INDIANA DEPARTMENT OF TRANSPORTATION
Driving Indiana's Economic Growth

FINAL DRAFT MINUTES

October 18, 2012 Standards Committee Meeting

RE: Minutes from the October 18, 2012 Standards Committee Meeting

EXISTING STANDARD DRAWINGS 605-CNCC-02 CONCRETE CENTER CURB TYPE B (WITH MARKUPS)

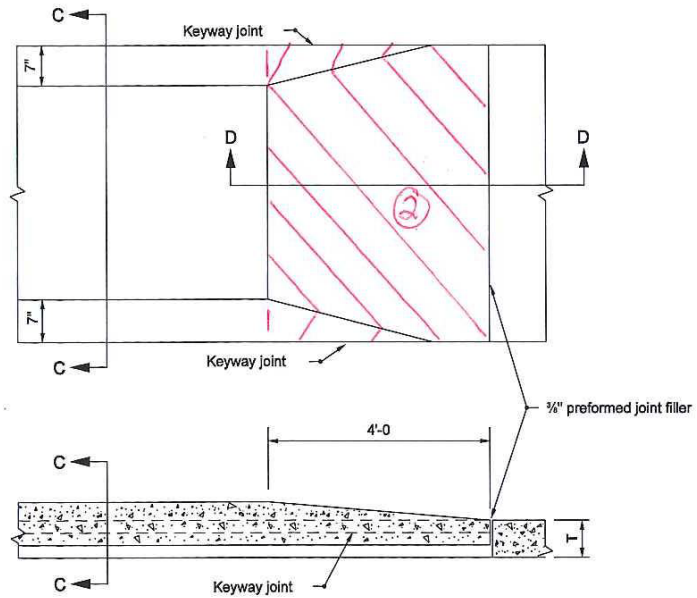
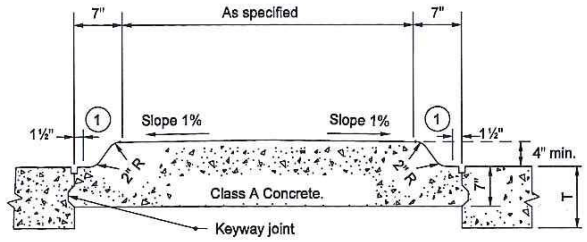
Revise 605.06 to require that yellow paint be applied on concrete center curb noses when shown on the Standard Drawings and revise the drawings to show yellow paint on curb types B through D.

(2) Apply yellow paint to nose of center curb.

BACKUP 01 EXISTING STANDARD DRAWINGS 604-SWCR-03 SIDEWALK CURB RAMP TYPE A (SEE PROPOSAL SHEET)

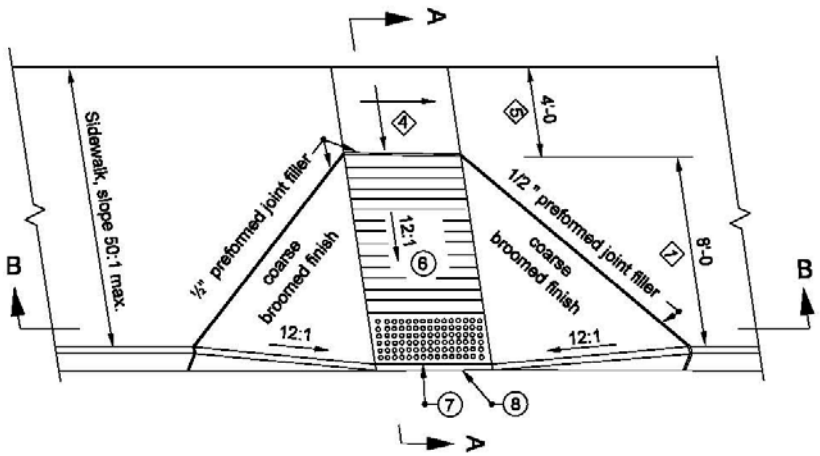
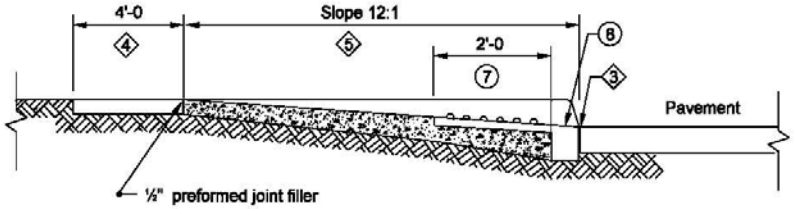
Also, there is contractor confusion on when curb ramps should be painted yellow. Normally only the part of the curb ramp that is a trip hazard should be painted.

PROPOSED SOLUTION: Revise 604.03 so that yellow paint is only applied if required (i.e. if the side slopes will have pedestrian cross traffic and they will be steeper than 12:1).

~~The exposed surfaces of the curb throughout the width of curb ramps~~ *If the curb ramp side slopes will have pedestrian cross traffic and the side slopes will be steeper than 12:1, the side slopes* shall be painted yellow in accordance with 808.06. Silica sand shall be applied to the wet paint along the top of the curb at the rate of 6.0 lb/gal. ~~(0.7 kg/L)~~.
